Town of Hilton Head Island Regular Design Review Board Meeting

Tuesday, May 12, 2015

**Town of Hilton Head Island
Design Review Board
Minutes of the Tuesday, April 28, 2015 Meeting
1:15p.m. – Benjamin M. Racusin Council Chambers**

Sheet Title:
PLANS AND SECTIONS

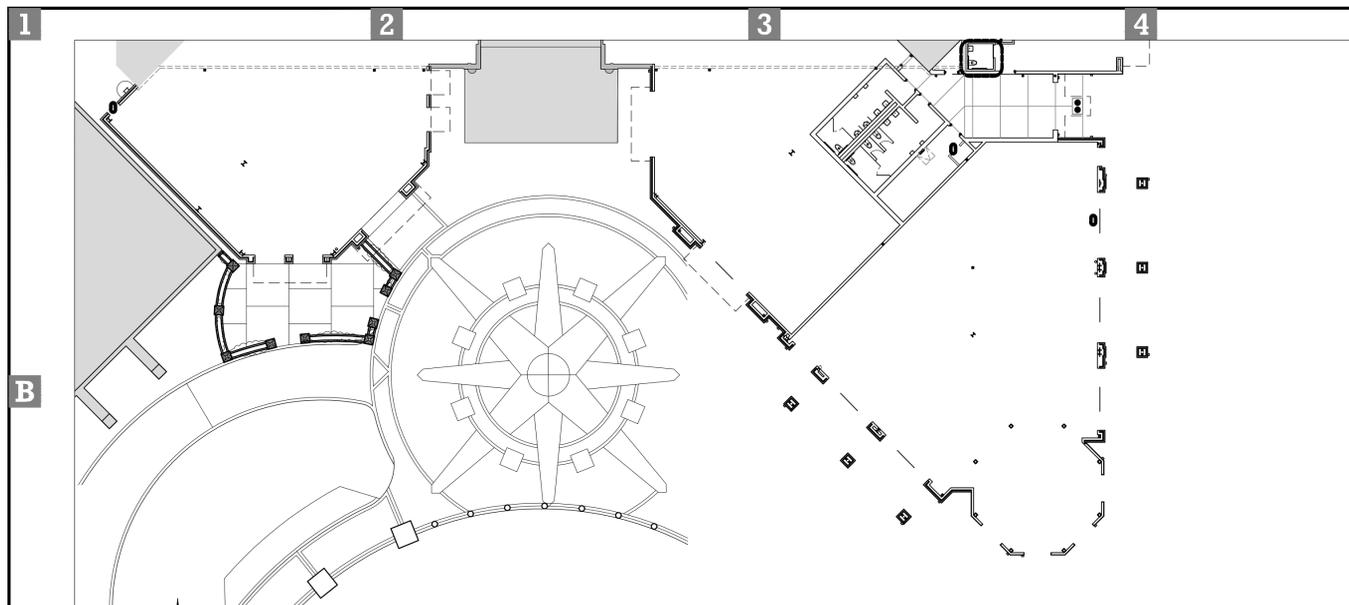
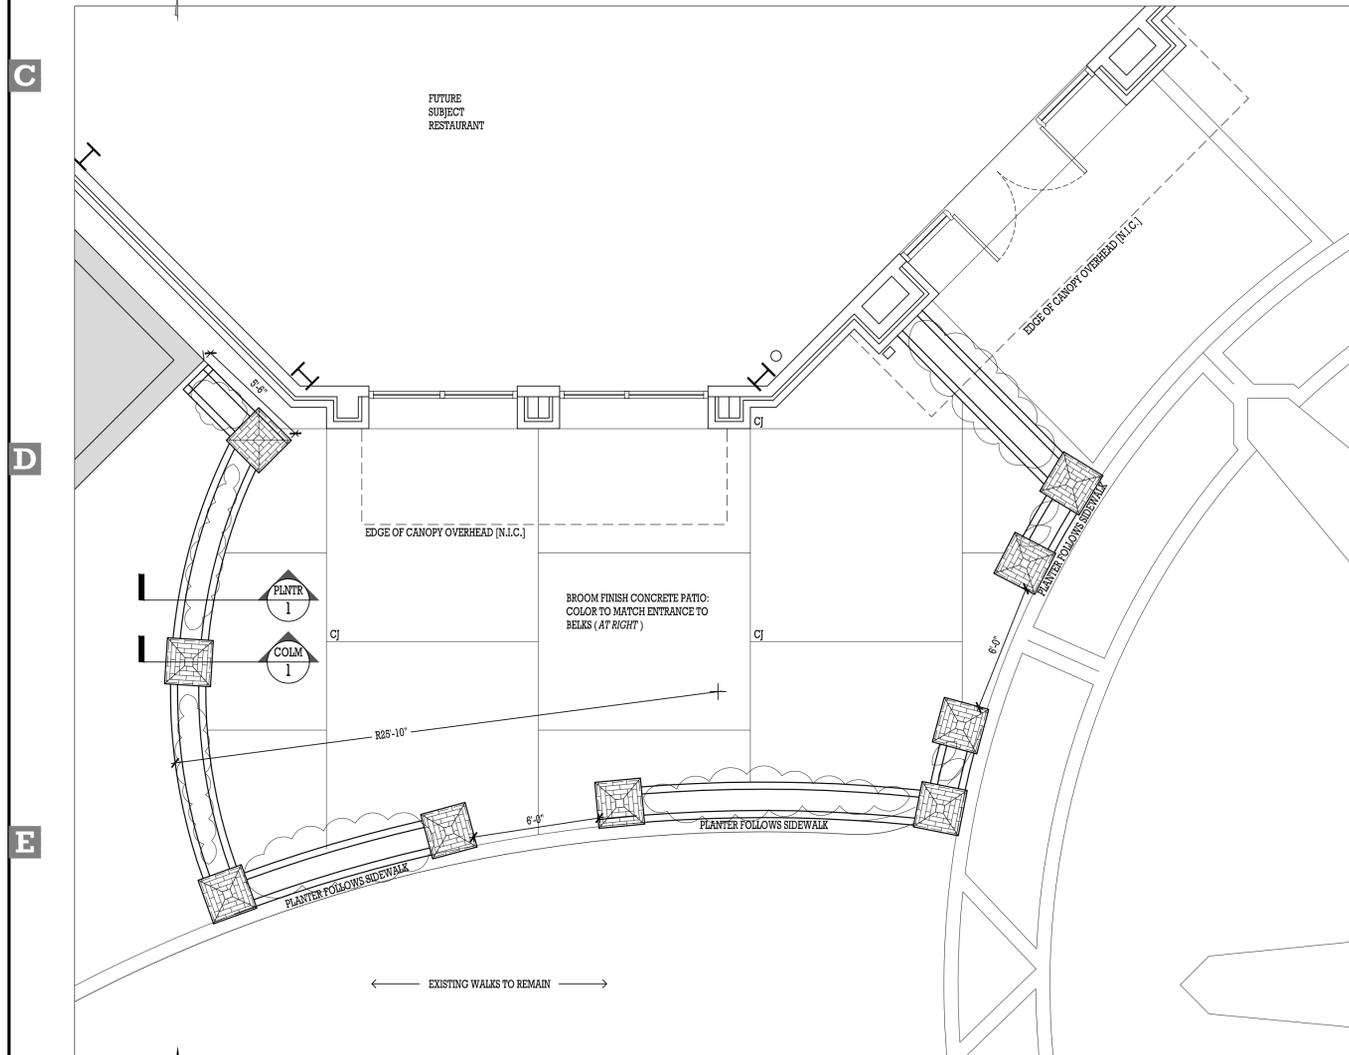
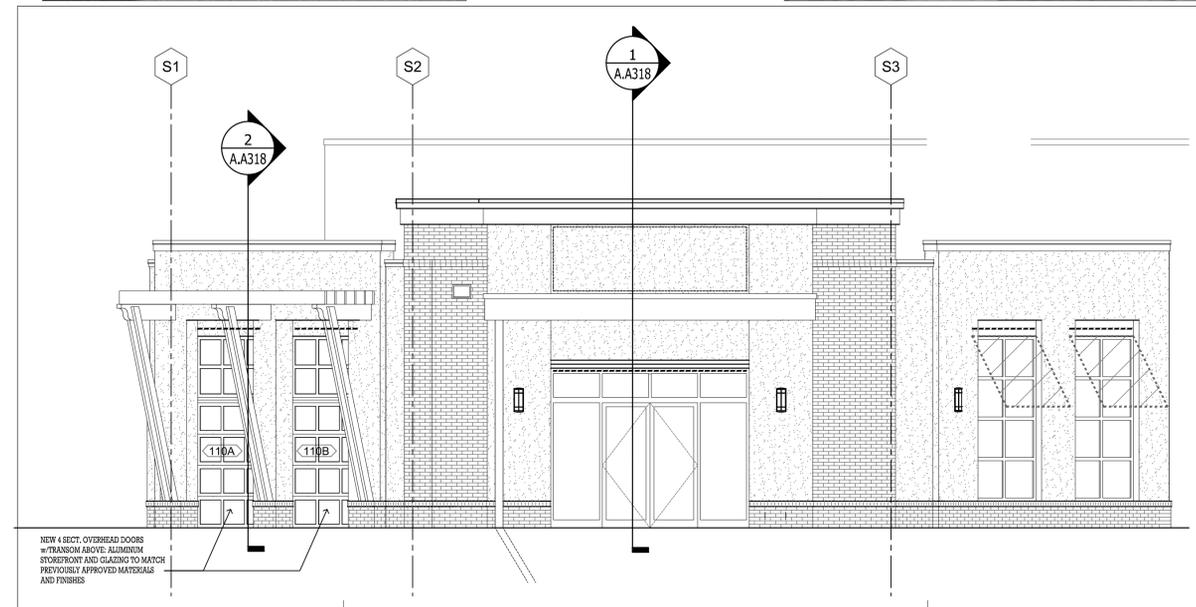
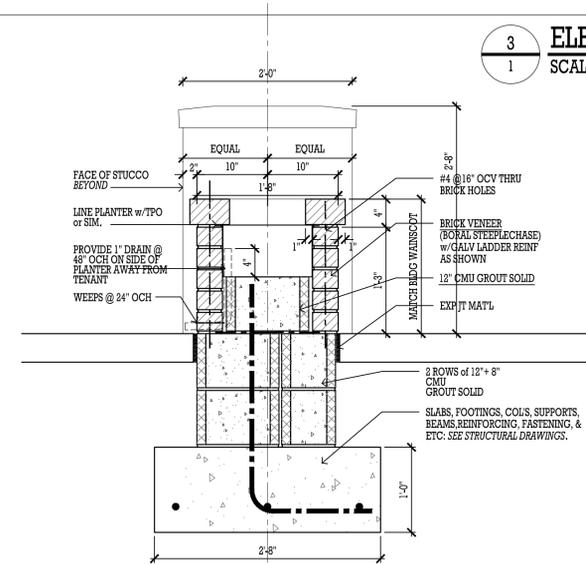
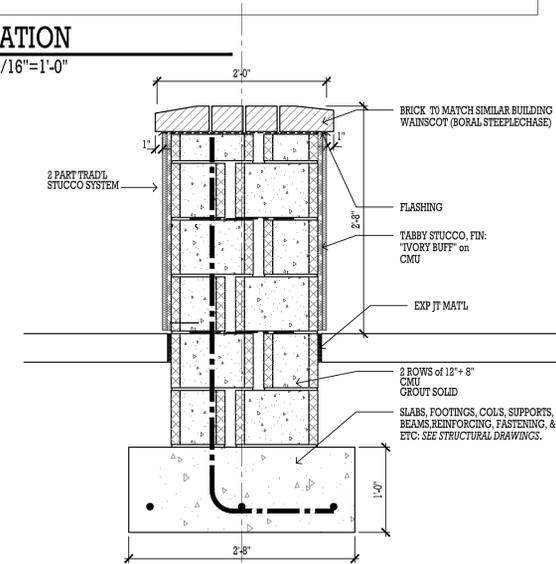
The applicant proposes to add outdoor dining for a restaurant coming to the existing building 110 at SCTC. Overhead doors will replace existing windows in order to provide access to a new patio (+/- 400 SF) that is located adjacent to building 110 and in front of building 108, Versona. The proposed patio is intended to be concrete with brick/stucco planters to provide separation between the outdoor dining and the adjacent sidewalk.

The proposed planters are in keeping with the existing building materials and detailing. The location of the planters should be adjusted to the existing sidewalk. The patio is proposed to be broom finish concrete in a color to match the entrance to Belk. There are several colors of concrete with a more elaborate score pattern in the area. The proposed color needs to be specified and the control joints designed to have a relationship to the patio. An existing light pole is located in the area of the proposed patio. Plans should be updated to indicate the proposed relocation of the existing light.

The approved landscaping in front of the adjacent building 108 will be modified due to the addition of the patio. A taller accent plant should be considered at the end of building 108 and the materials in the planters should be reevaluated for consistencies (i.e. fig vine in only 2 of 7 planters, at 1 of 2 entrances) and simplification as well as potential maintenance issues.
